**ER0023**  
**Errata**  
**SmartFusion Devices**

This errata sheet contains updated information about any known SmartFusion<sup>®</sup> device family specific issues and provides available fixes and solutions.

**Figure 2 • Sampling Simultaneous Operations**

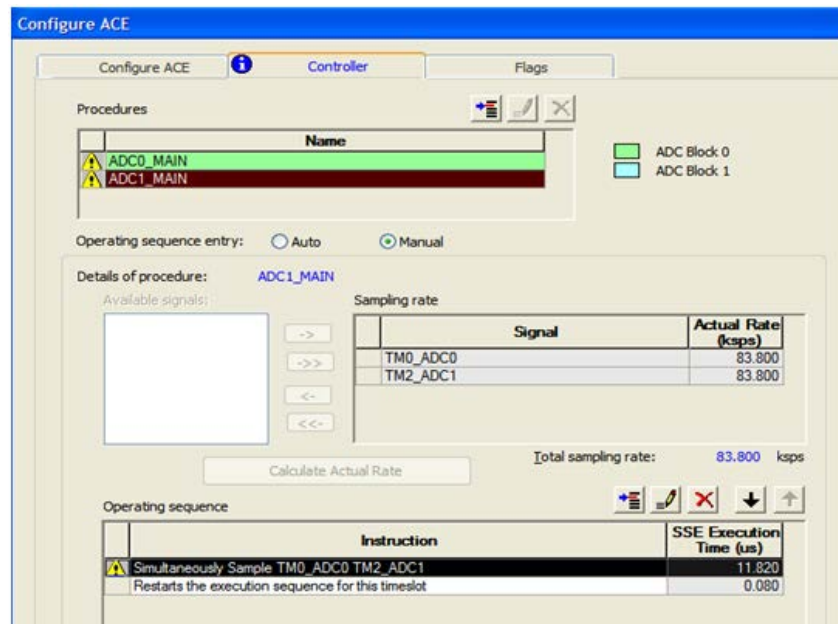
In such a situation there is contention of the ADC resources. This leads to the ADC sampling data being dropped occasionally, as indicated by the warning message shown in the following figure. To fix this issue, you can either change the procedure specification, so you don't use the same ADC in the multiple

procedures or the firmware must enable/disable the procedures so that the conflicting procedures are not simultaneously active at the same time.

*The ACE driver Use Guide* has an API that you can use to enable/disable the procedures.

Figure 4 • Reset Management Configurator

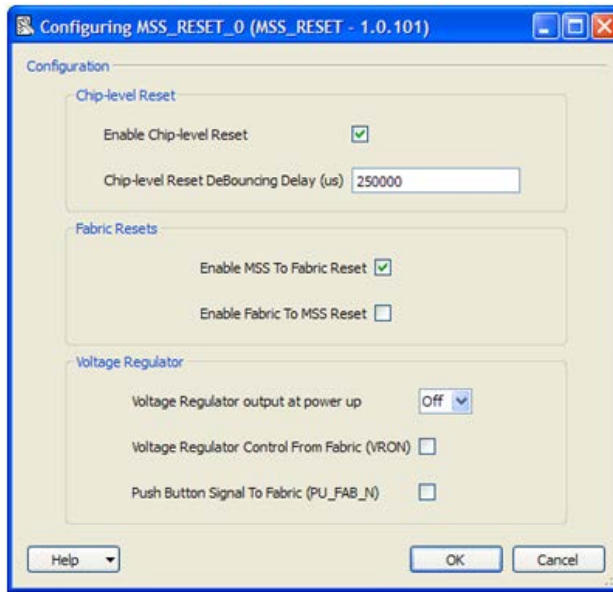
This issue happens if the debouncing delay generated by the external reset chip does not match the chip level reset debouncing delay specified in the Reset Management configurator in the MSS, as shown in the following figure.

Ensure that the chip level reset debouncing delay specified in the Reset Management configurator in the MSS matches the external reset chip delay.

Figure 5 • System Behavior Option after System Configuration

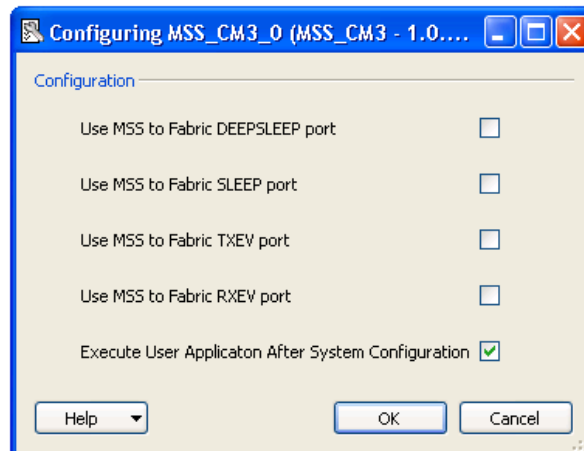
When there is no application design, the device periodically resets after system configuration, even though the Watchdog was disabled. The system boot should not go to the application if there is no application specified.

A new option, **Execute User Application After System Configuration**, has been added into the Cortex-M3 configurator as per the following figure, that gives the user the flexibility of deciding the behavior after the system configuration. The option is ON by default, which indicates that your application is executed after system configuration. If you do not have any application to run, the check box options should be cleared.

**Figure 7 • ACE Data Path Available Tapping Points**

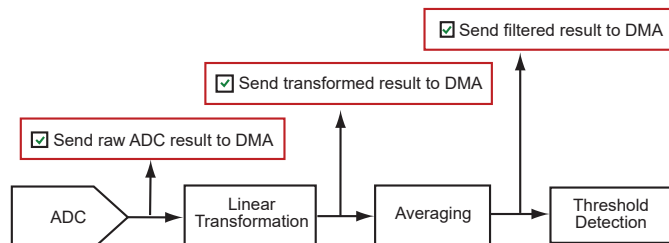
In Libero SoC v10 SP1, the PPE microcode is incorrectly generated when **Send filtered value to DMA** is enabled. Prior to Libero SoC v10 SP1 the microcode was generated correctly.

Update to Libero SoC software v10 SP2 or later.
